General Conformance of Construction

Date:	March 25, 2025	Project Number:	2401823
Attention:	Neal Damgaard, P.Eng.	Project Description:	Bosworth Creek Abutment Repairs
Company:	Imperial Oil Resources (IOR)	File Number:	500
Email:	neal.r.damgaard@esso.ca	From:	Don Williams, P.Eng.
Copy To:	File

RE: Completion of the Bosworth Creek Abutment Repairs (Alternate Design)

**ABUTMENT REPAIR
DETAILS SHEET 1**

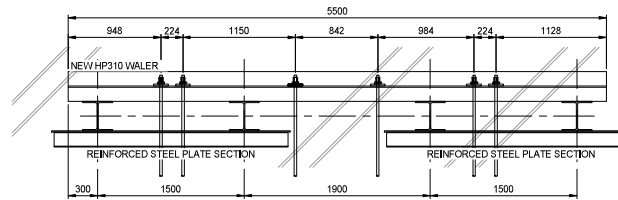
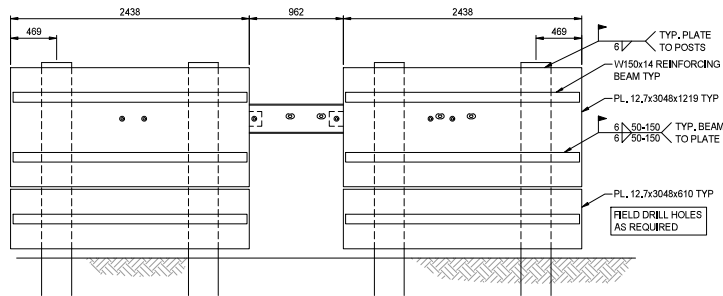
RFI:
Drawing 2401823-000-1960-206 shows the existing waler to be 549mm +/- to top of pilings, the actual is 1150mm from center of original waler location, Please advise if we are to continue with the current design using 549mm benchmark or to field fit the new W150x14 beams and PL 12.7x3048x1219 to match the actual 1150mm center of existing waler to top of piles ?

**ABUTMENT REPAIR
DETAILS SHEET 1**

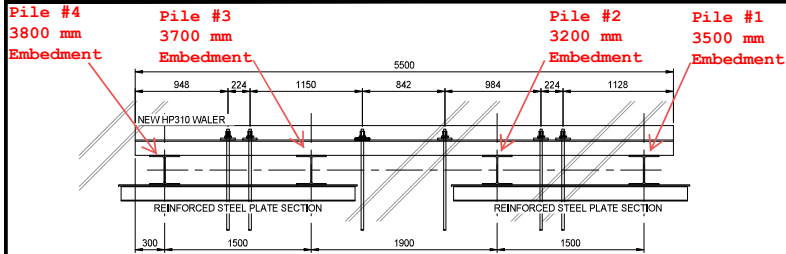
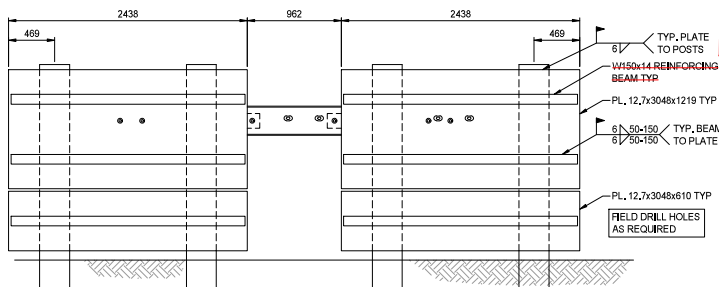
- Resupporting the existing sheet pile wall waler beam with steel plates connected to the top and bottom flanges (not included in the design drawings).
- The steel plates along the front of the new and existing dead man wall piles were reinforced with W150x12 beams instead of the W150x14 beams specified in the design.

- 2) The red line drawings provided by Graham show that the steel plates along the front of the new and existing dead man wall piles were reinforced with W150x12 beams instead of the W150x14 beams specified in the design. However, the material requisition form provided by Graham shows that W6x12 beams (metric equivalent = W150x18) were ordered. We assume that this is just a typo on the red line drawings, but can you confirm which type of beam was used to reinforce the steel plates?

W150 x 12 Reinforcing Beam

- 1) Yes, they were reinforced with 12.7mm plate at both ends of both
- 2) W150x12 is correct and was approved to use by Don William
- 3) I will look at what we have and send to you

DWG NO: **2401823-000-1960-203** REV: **0**

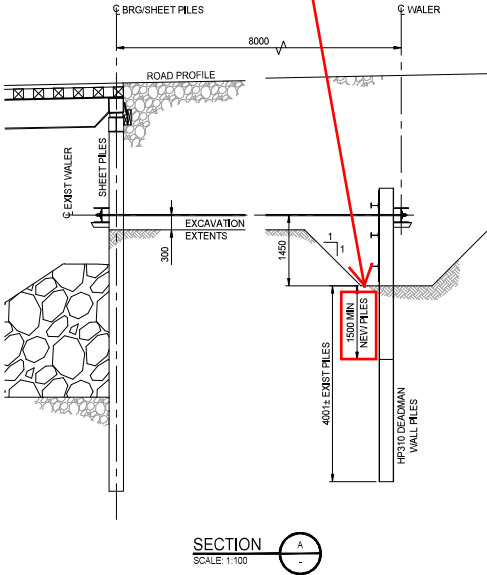
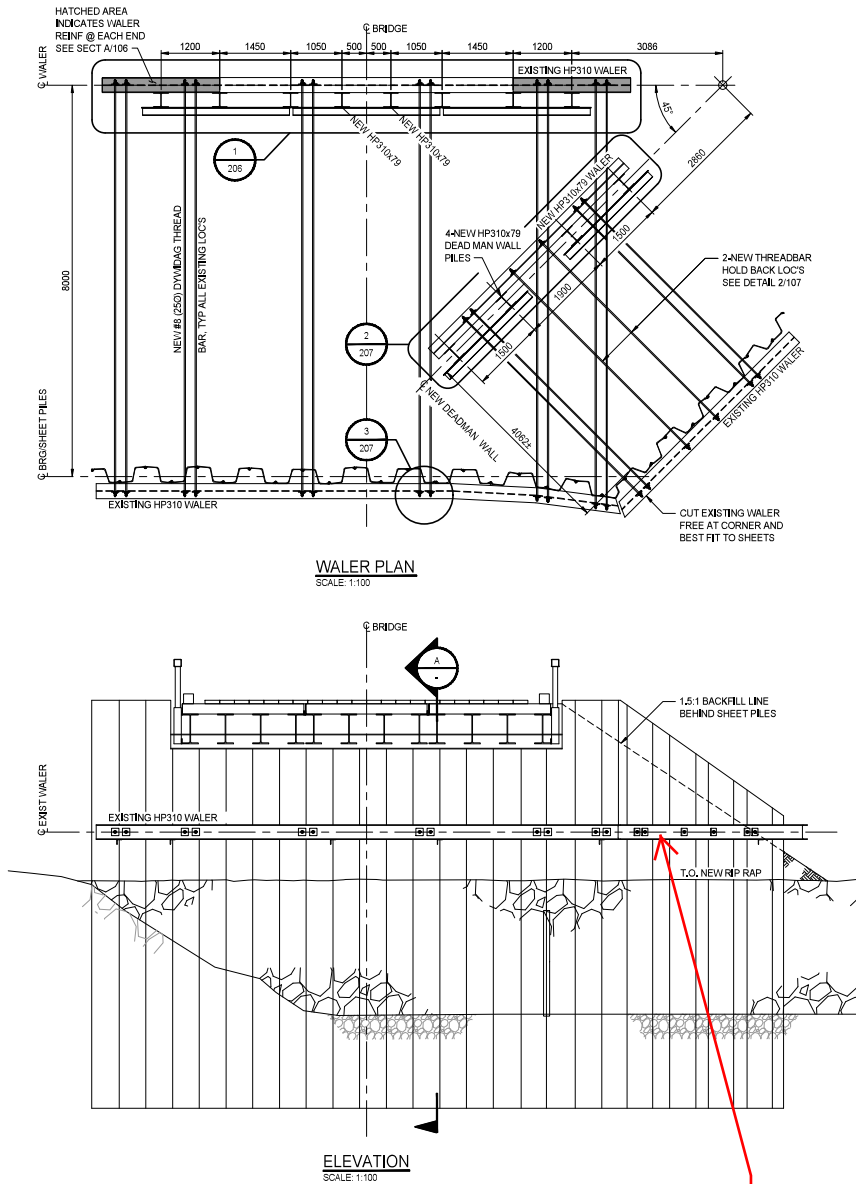
PILE EMBEDMENT RANGES
FROM 3200mm TO 3800mm

EXISTING SHEET PILE WALL WALER BEAM RESUPPORTED WITH
STEEL PLATES CONNECTED TO THE TOP AND BOTTOM FLANGES

**ABUTMENT REPAIR
DETAILS SHEET 1**

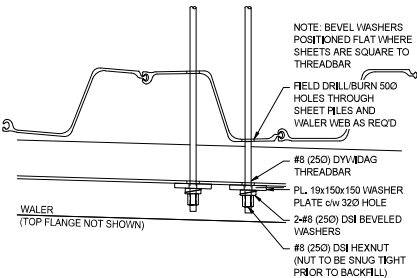
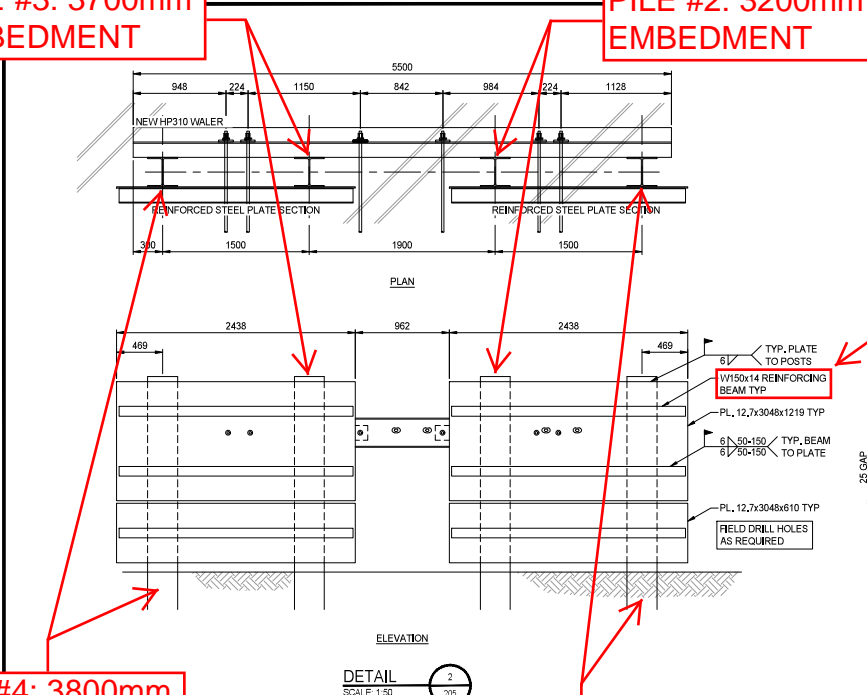
PILE #3: 3700mm
EMBEDMENT

PILE #2: 3200mm
EMBEDMENT

PILE #4: 3800mm
EMBEDMENT
